Private Fuel Storage, L.L.C.

**SUPPLEMENTAL RESPONSE TO RAIs
PRIVATE FUEL STORAGE FACILITY
DOCKET NO. 72-22 / TAC NO. L22462
PRIVATE FUEL STORAGE L.L.C.**

SAR CHAPTER 2 - SITE CHARACTERISTICS

Plate 2. — MAP SHOWING THE GENERALIZED DISTRIBUTION OF DISSOLVED SOLIDS IN GROUND AND SURFACE WATERS, THE CHEMICAL CHARACTER OF REPRESENTATIVE WATER SOURCES, AND THE RELATION OF QUALITY TO THE SOURCES OF RECHARGE AND THE AREAS OF DISCHARGE IN SKULL VALLEY, TOOELE COUNTY, UTAH

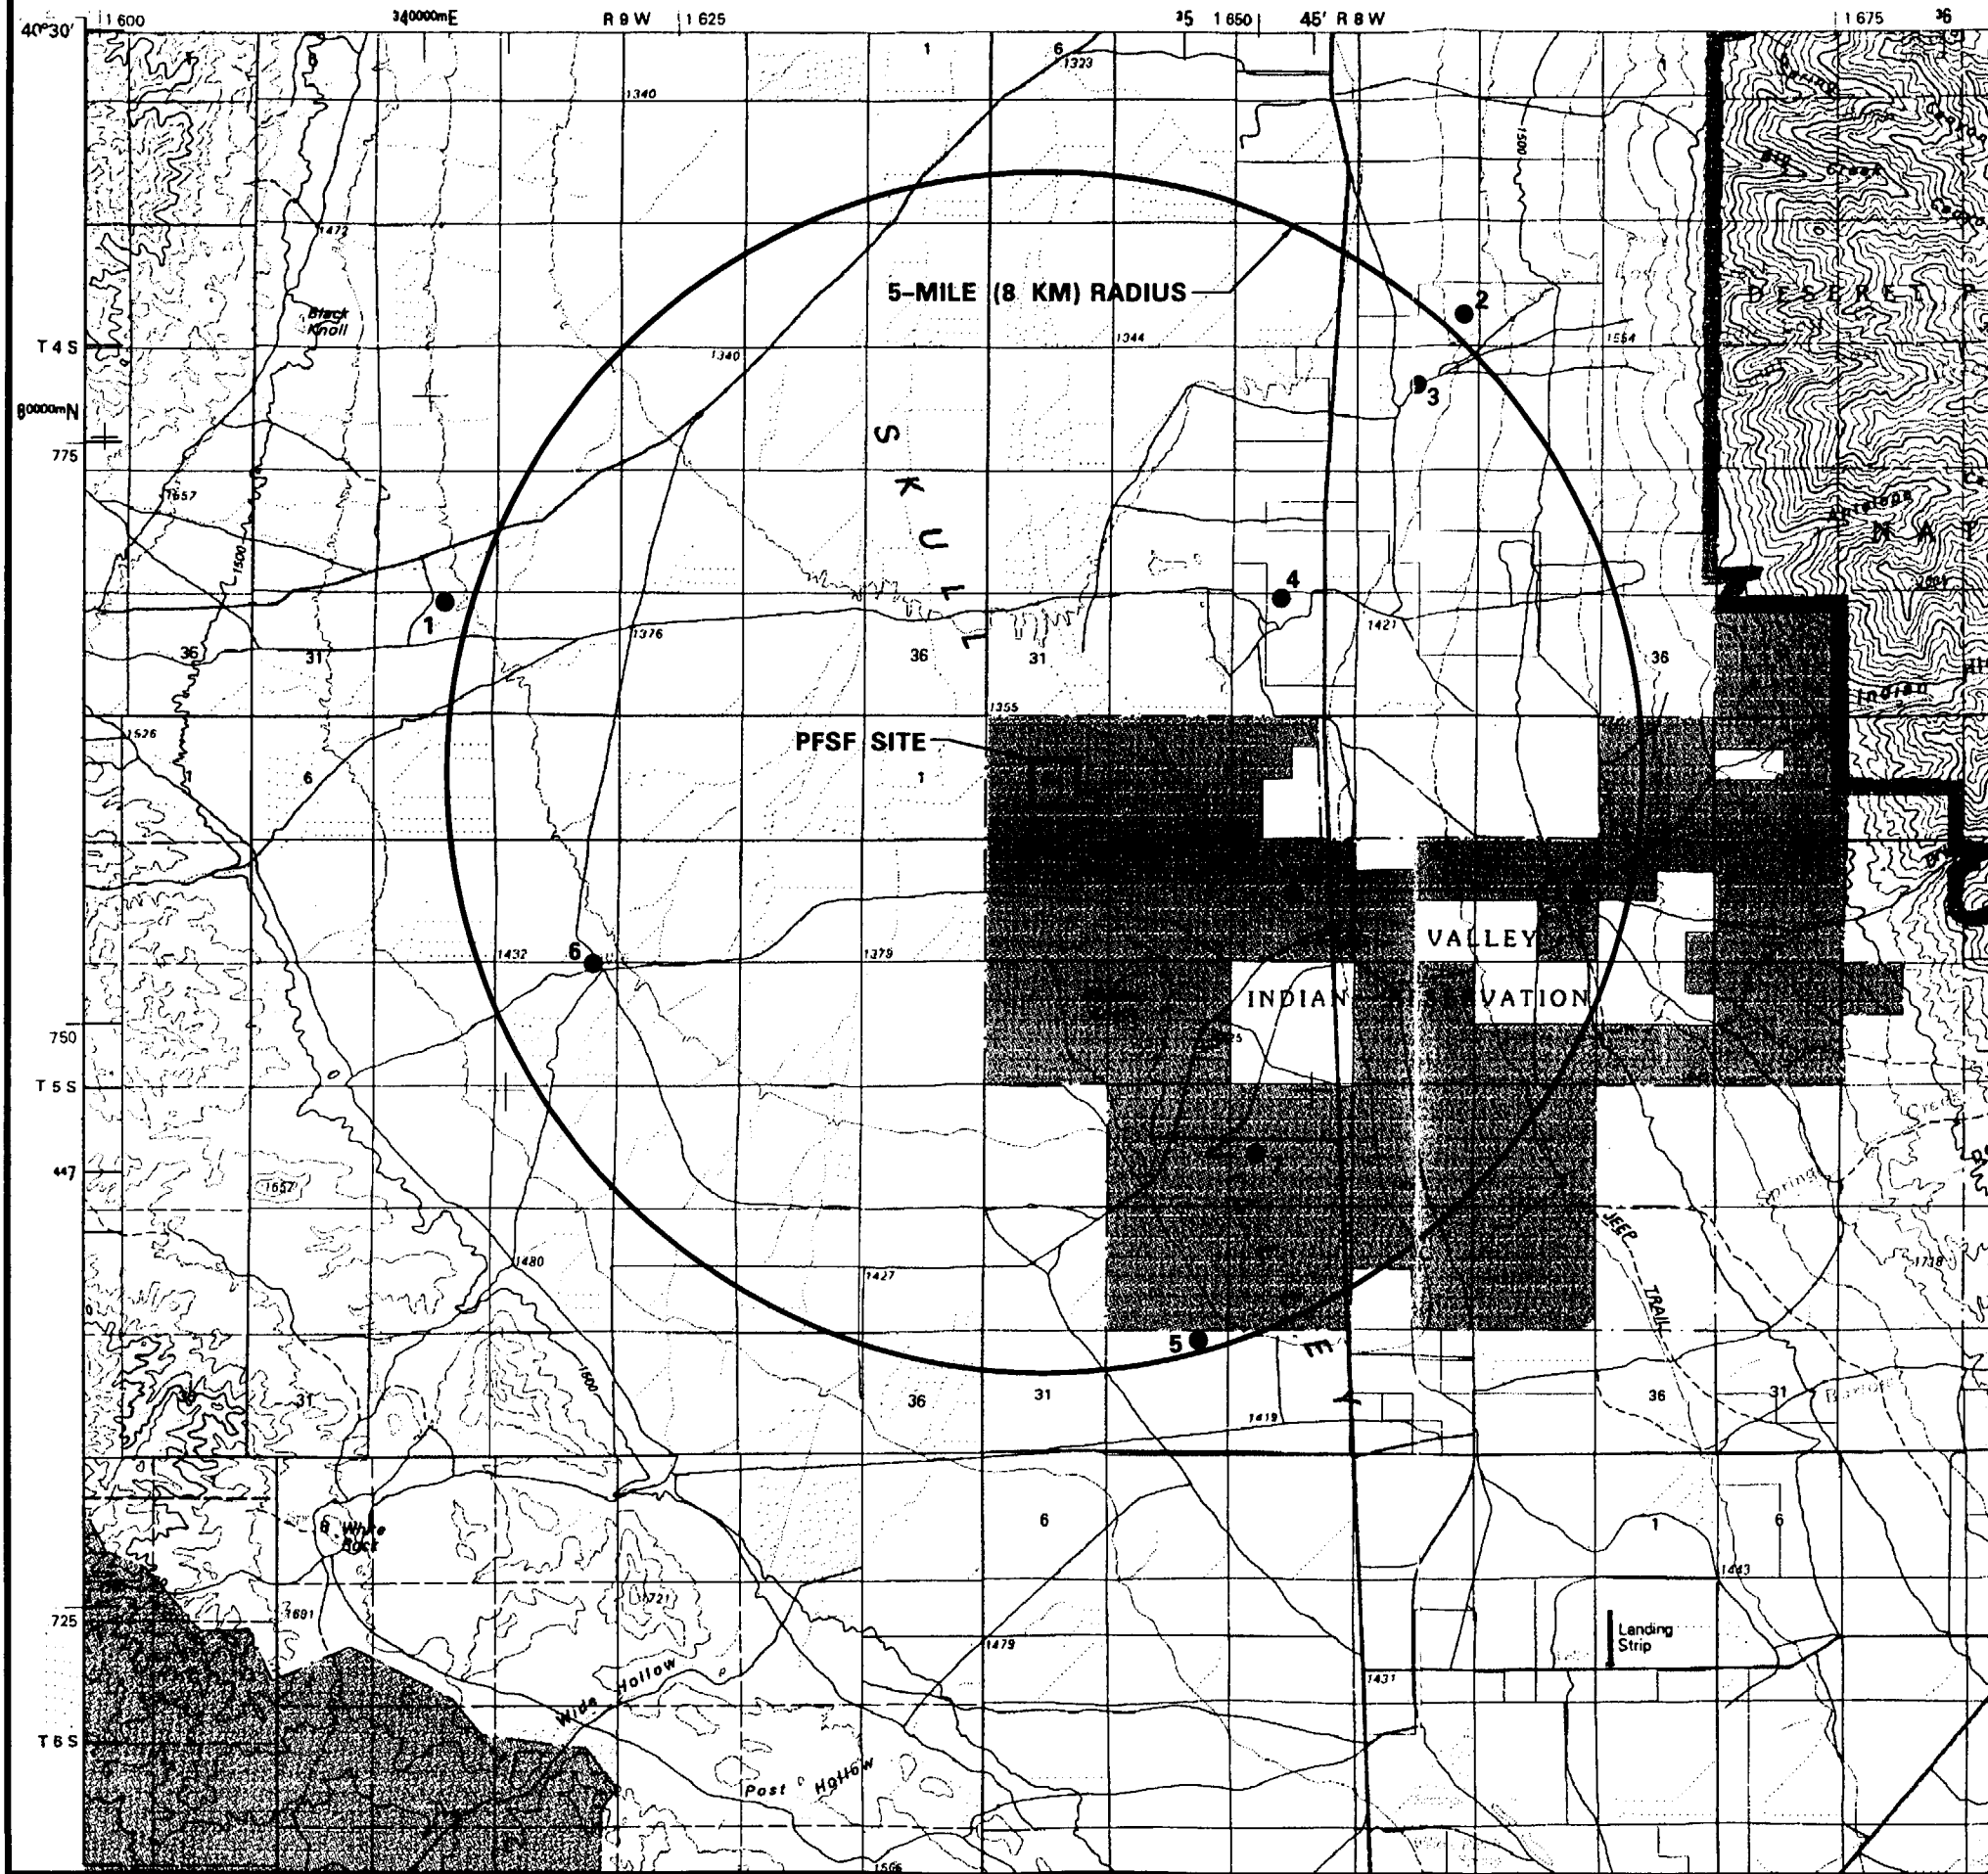
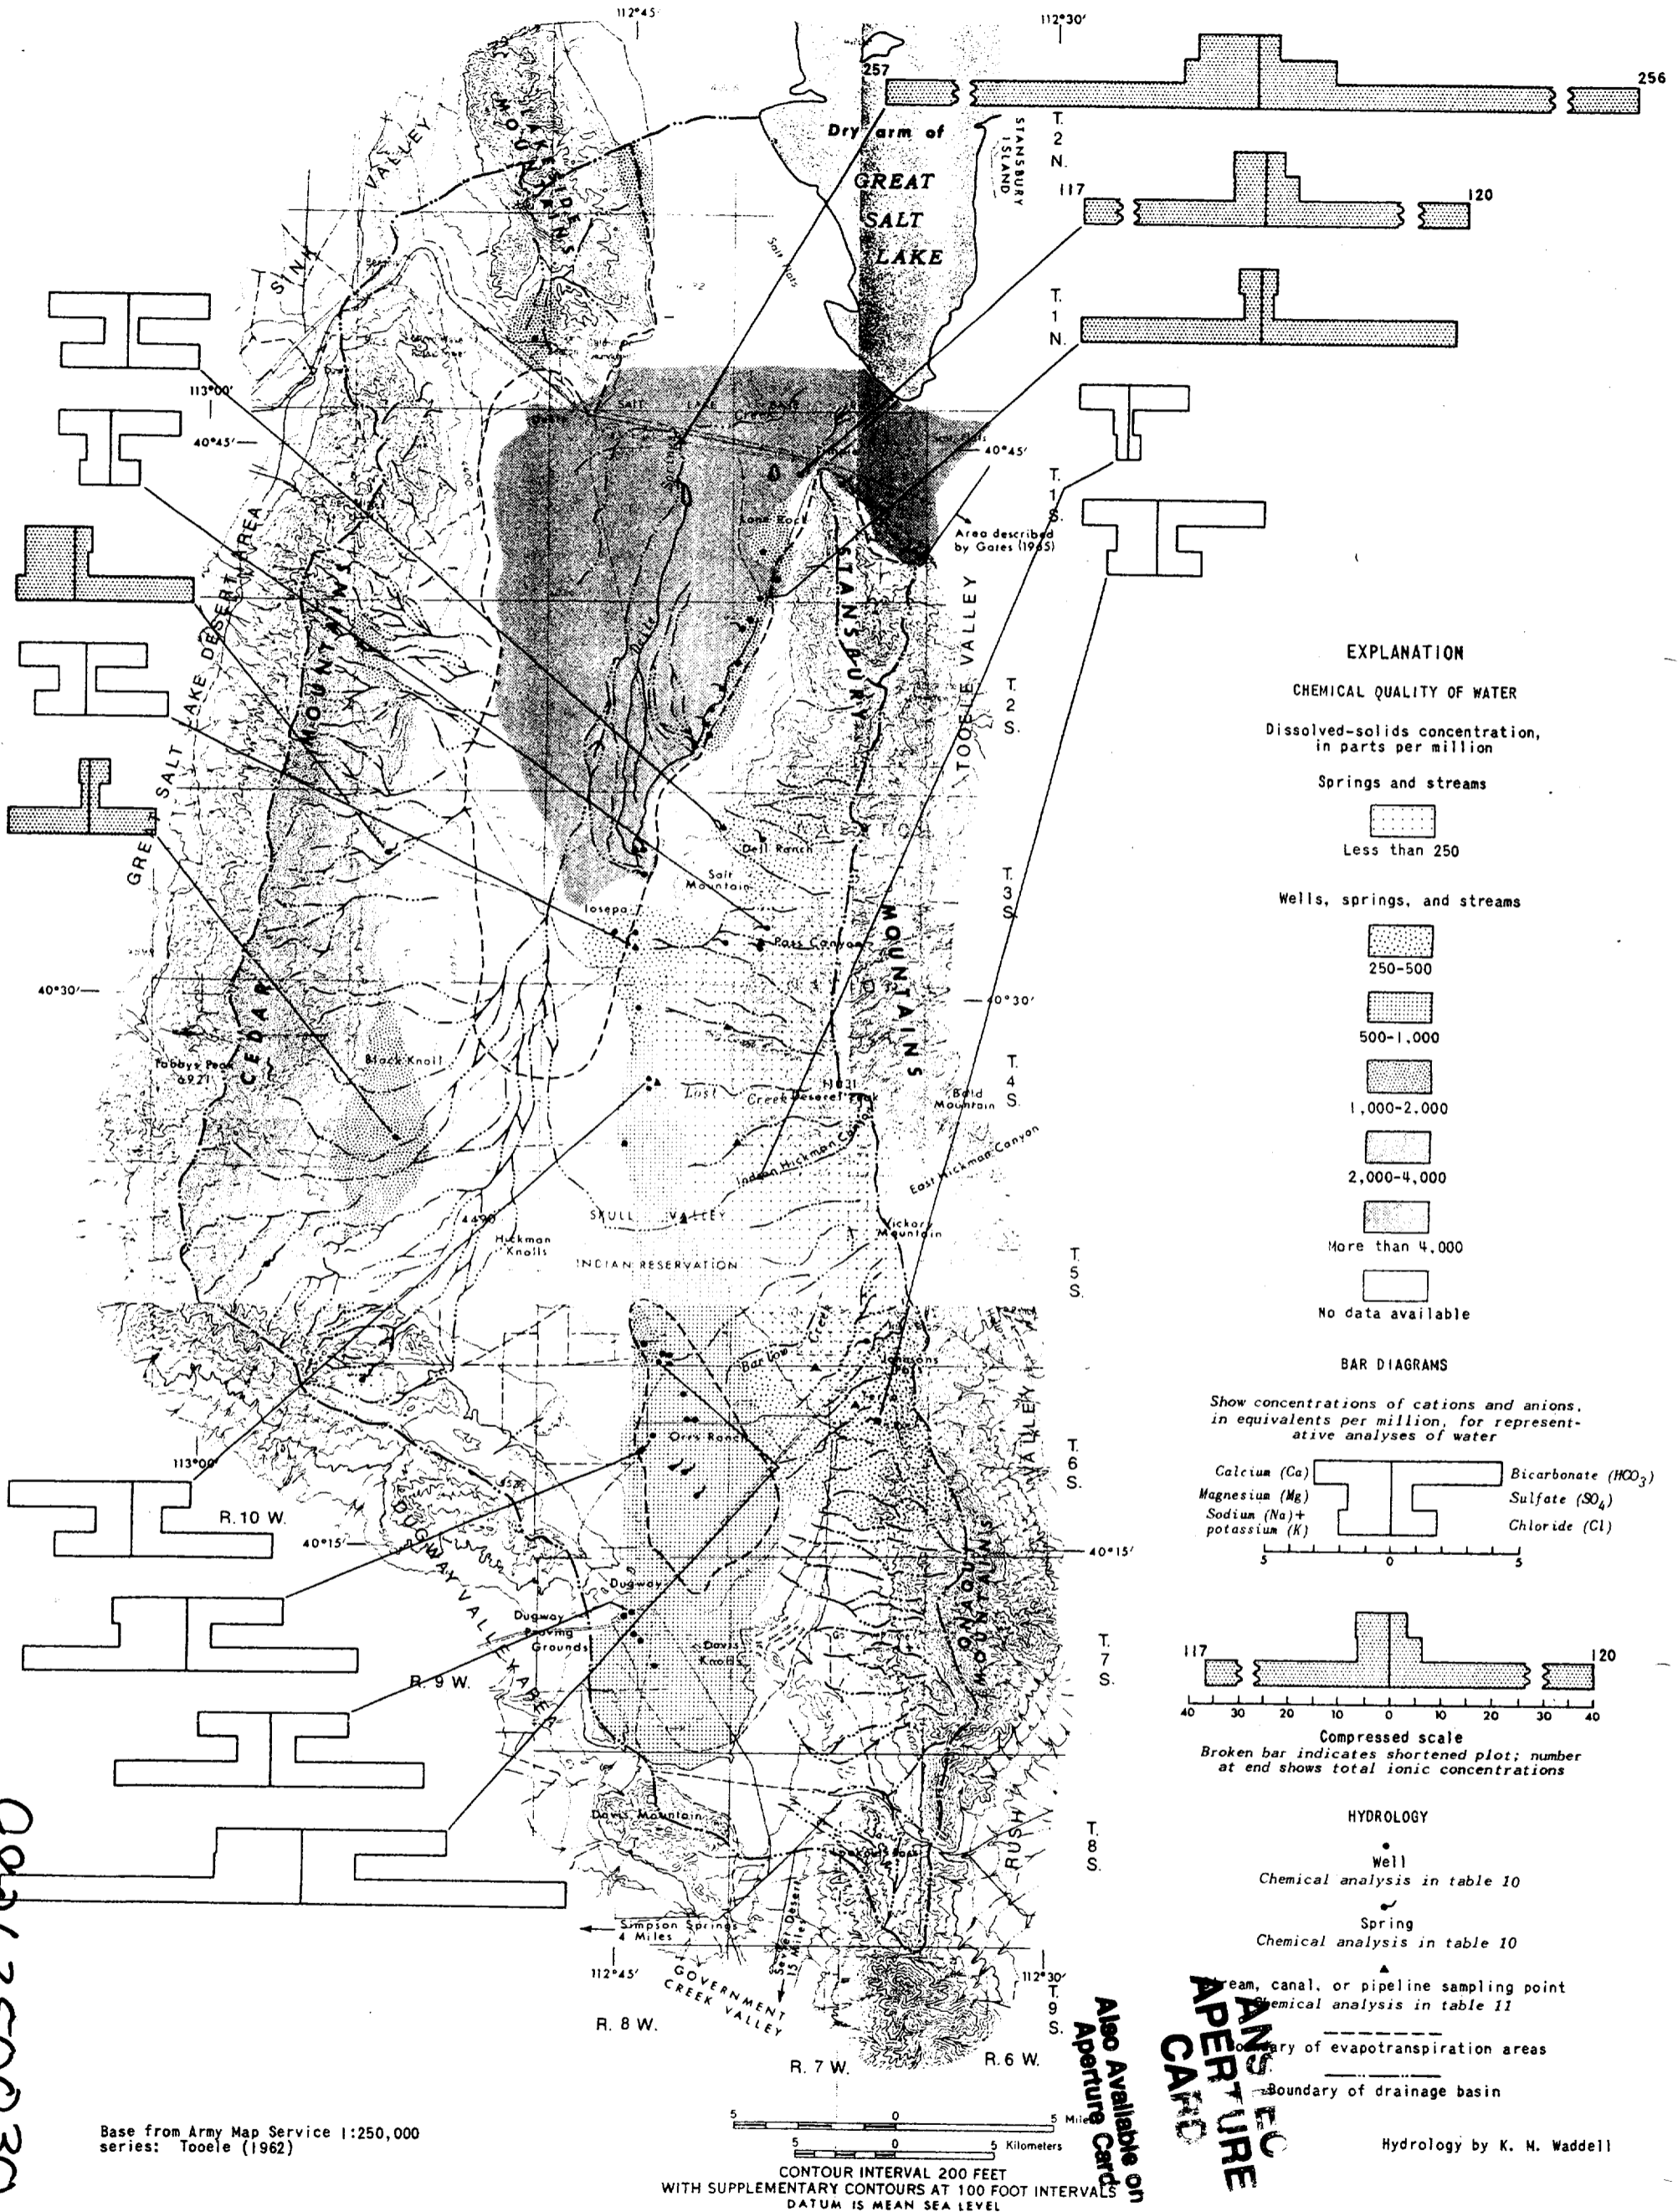
- (d) Potentiometric contours of groundwater at and around the proposed PFSF site (if relevant).
 - (e) Classification of the aquifer beneath the PFSF site based on class of use and water quality (if relevant).

- (c) See response to (a), above.
- (d) The potentiometric map (Plate 1) from Hood and Waddell is included as part of this response.
- (e) The State has not applied an aquifer classification system to the aquifer in Skull Valley. A water quality map (Plate 2) from Hood and Waddell is included as part of this response.
